Product Change Notification / GBNG-06GBPZ091

CCB 3640 Final Notice: Qualification of MTAI as a new final test site for selected Atmel products available in 20L PLCC package.

Pre and Post Change Summary

QUALIFICATION REPORT SUMMARY

TUBE DRAWING - 20L PLCC

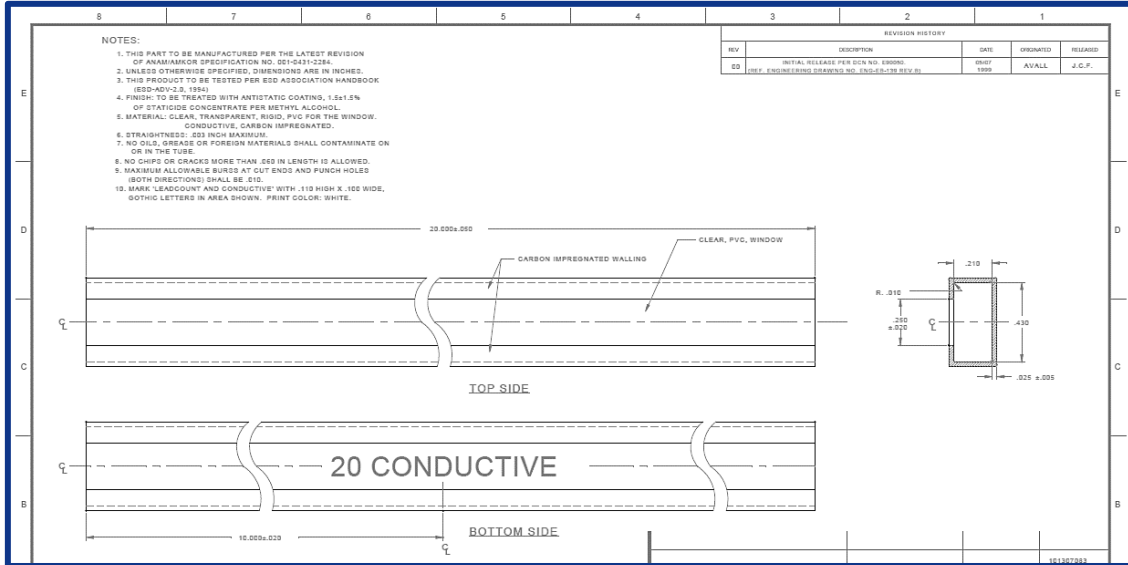
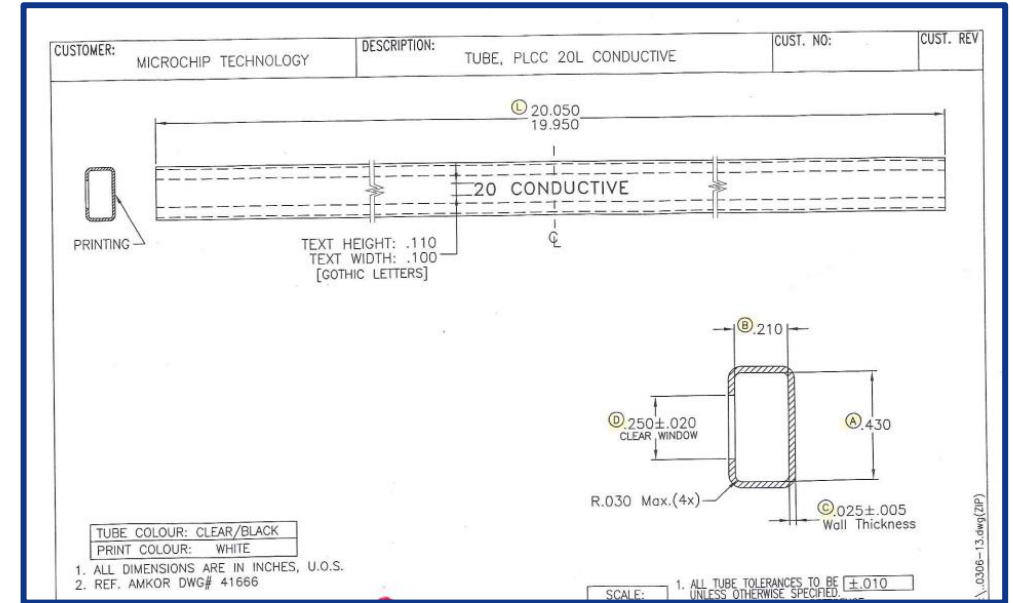
Plant	Length (in)	A (in)	B (in)	Thickness (in)	Color	Unit per Tube
ATP7	20.00 +/-0.050	0.210 +/-0.010	0.430 +/-0.010	0.025 +/-0.005	Conductive/Window	48
MTAI	20.00 +/-0.050	0.210 +/-0.010	0.430 +/-0.010	0.025 +/-0.005	Conductive/Window	48

TUBE PACKING METHOD - 20L PLCC

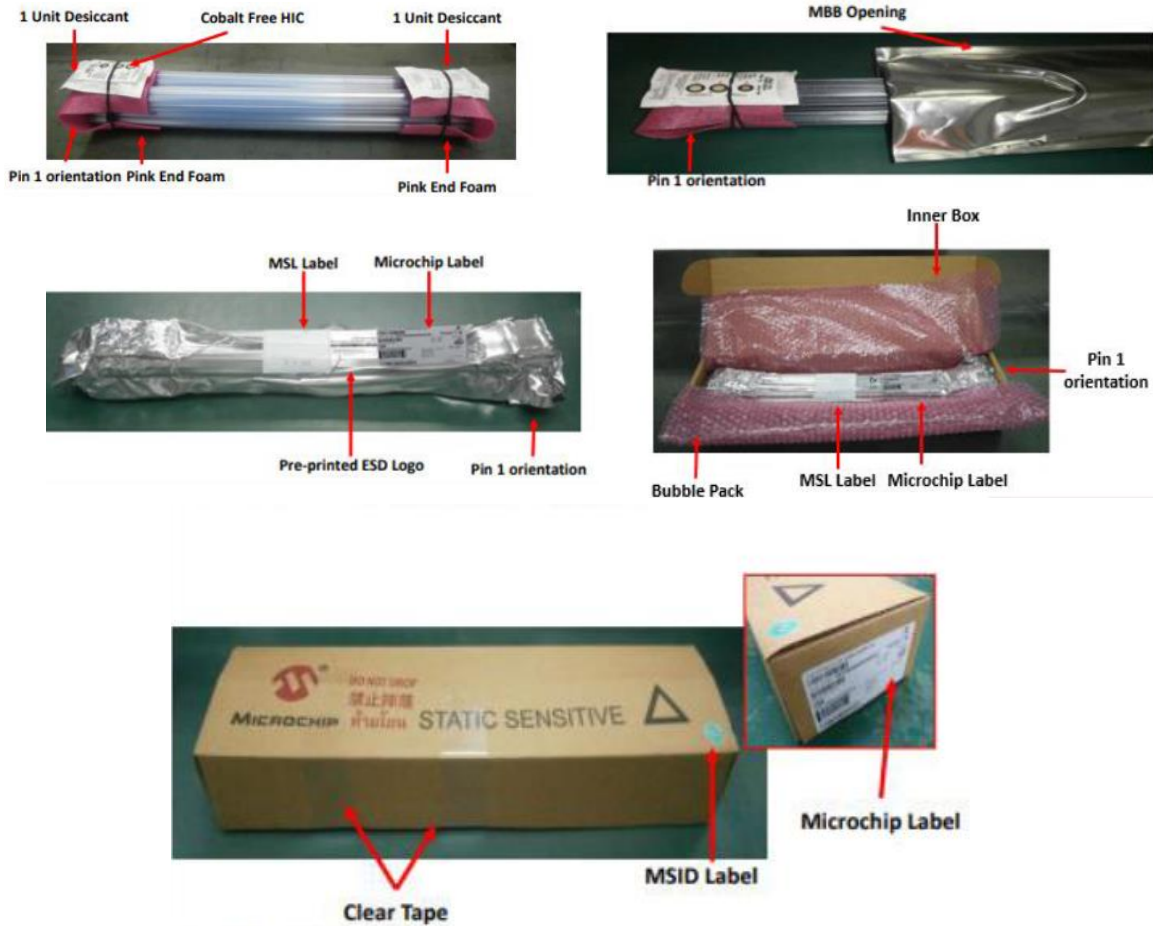
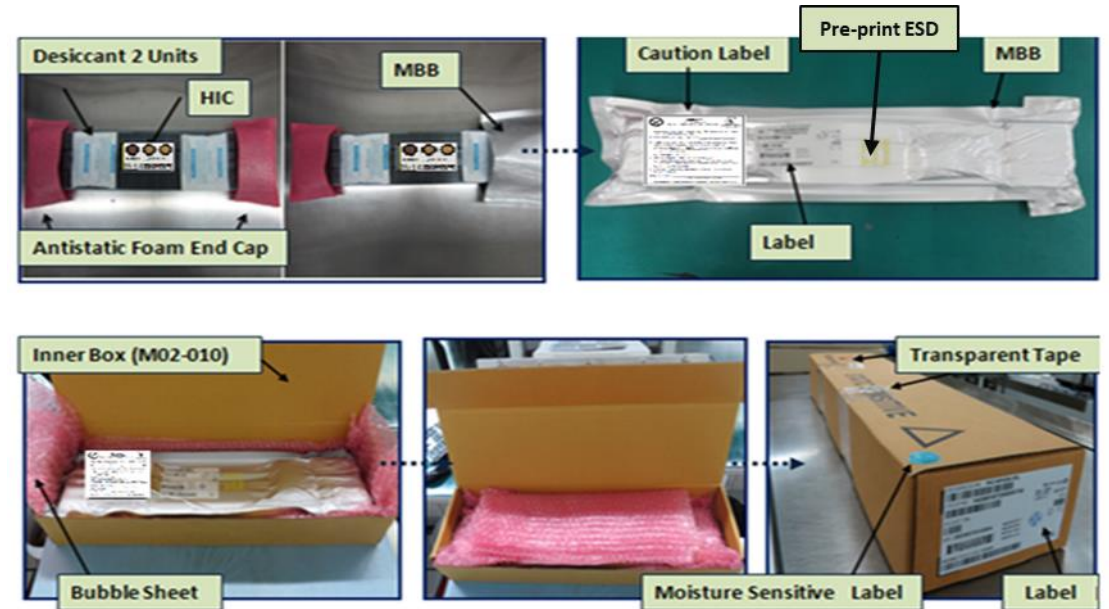
Scan & Pack Site	Tube	Amkor Technology Philippines (P3/P4), INC (ATP7)	Microchip Technology Thailand (HQ) (MTAI)
	Tape & Reel	Microchip Technology Operations (Philippines) Corporation (MPHL)	Microchip Technology Thailand (HQ) (MTAI)
Tube Drawing		No dimensional change. See pre and post change comparison	
Tube Packing Method		See pre and post change comparison.	
Carrier Tape drawing		No dimensional change. See pre and post change comparison	
Cover Tape drawing		No dimensional change. See pre and post change comparison	
Plastic Reel drawing		Minor dimensional change. See pre and post change comparison	
Tape and Reel packing method		See pre and post change comparison.

CARRIER TAPE DRAWING - 20L PLCC

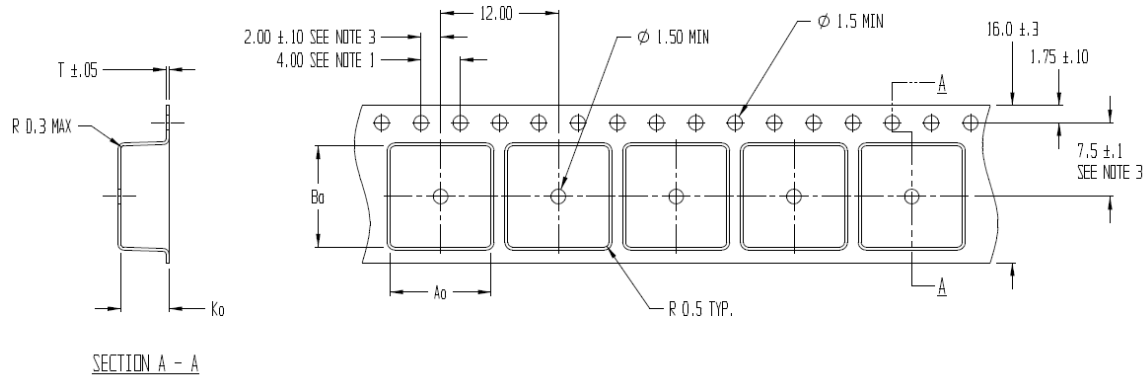
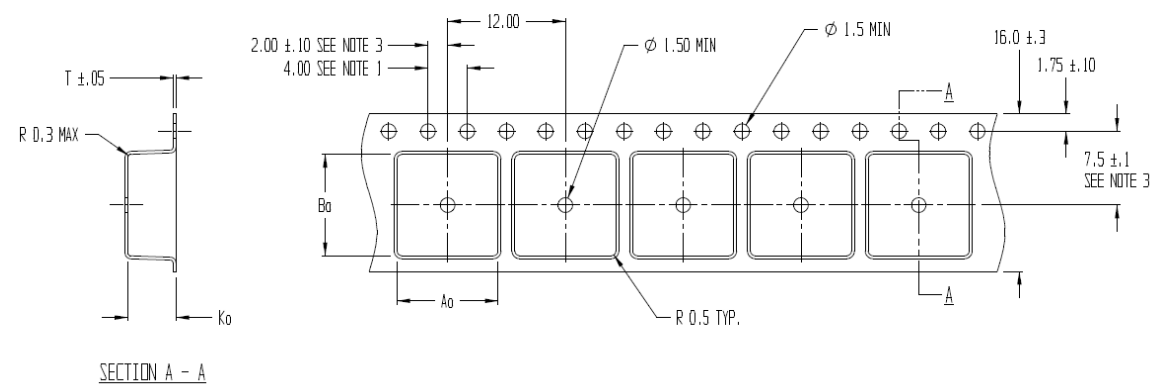
Plant	Supplier Mfg. part no.	Width (mm)	Pitch (mm)	A0 (mm)	B0 (mm)	K0 (mm)	Thickness (mm)	Unit per Reel	Pin Orientation
MPHL	PLCC20-AC	16	12	10.30	10.30	4.90	0.30	1,000	Quadrant 1-2
MTAI	PLCC20-AC	16	12	10.30	10.30	4.90	0.30	1,000	Quadrant 1-2

COVER TAPE DRAWING - 20L PLCC

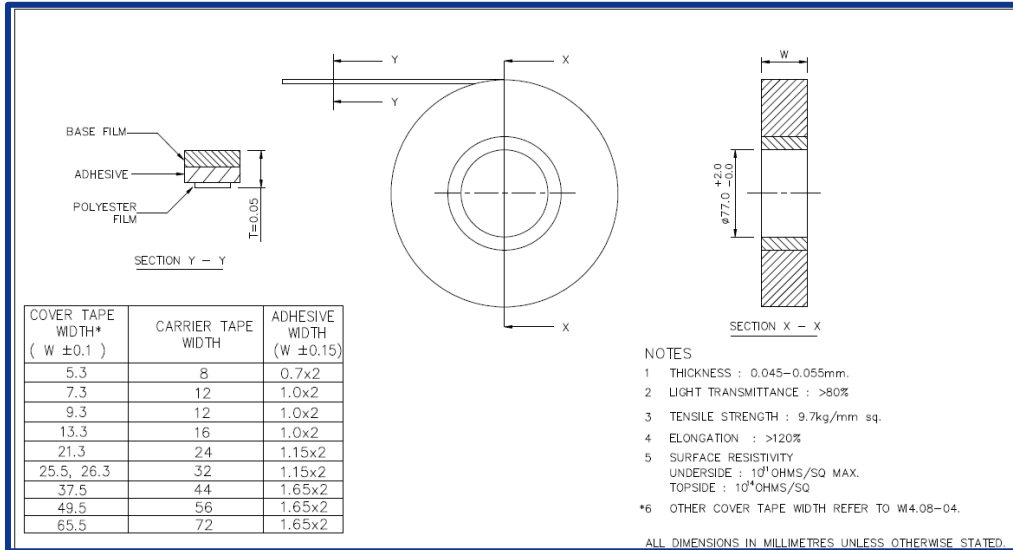
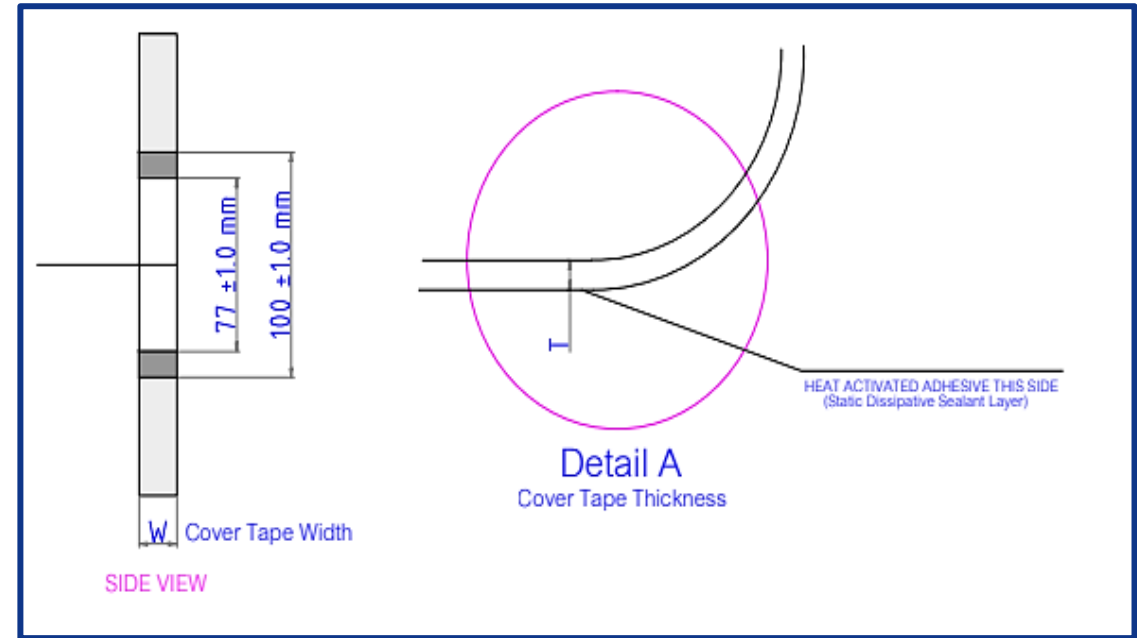
Plant	Supplier Mfg. part no.	Width W (mm)	Thickness "T" (mm)	Color	Sealing Methodology
MPHL	CP58 PSA	13.30 +/-0.1	0.050 +/- 0.010	Clear	Pressure Seal
MTAI	CSL-Z7302	13.30 +/-0.1	0.050 +/- 0.010	Clear	Heat Seal

PLASTIC REEL DRAWING - 20L PLCC

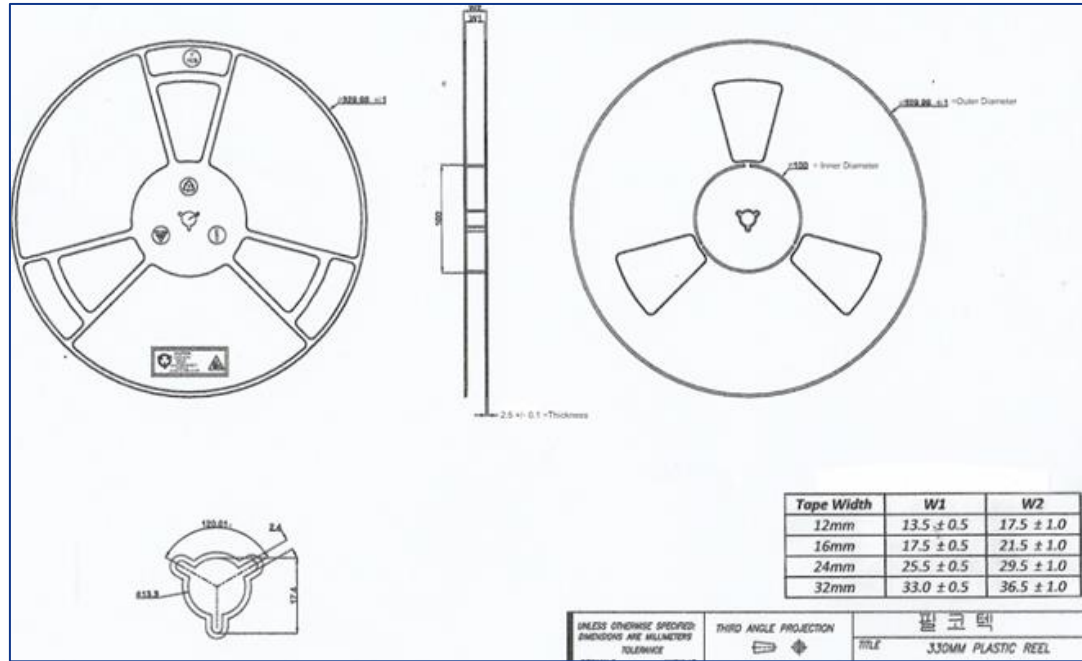
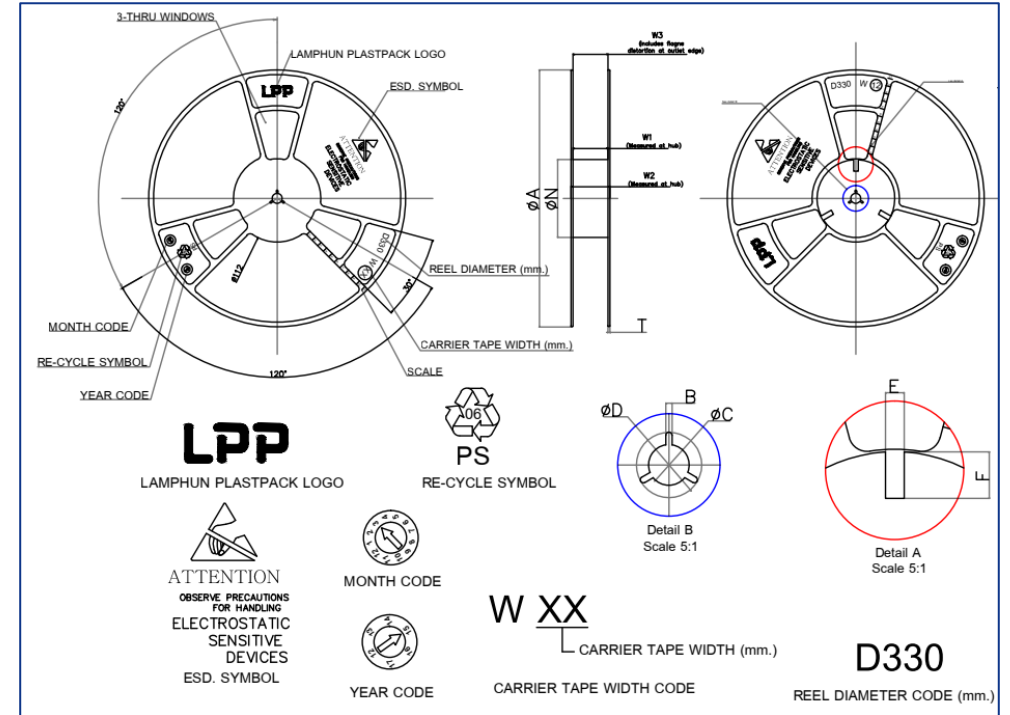
Plant	Reel Diameter (mm)	Reel Hub Size (mm)	W1 (mm)	W2 MAX (mm)	Color
MPHL	330	100	17.50	22.50	White
MTAI	330	100	16.40	22.40	Dark Blue
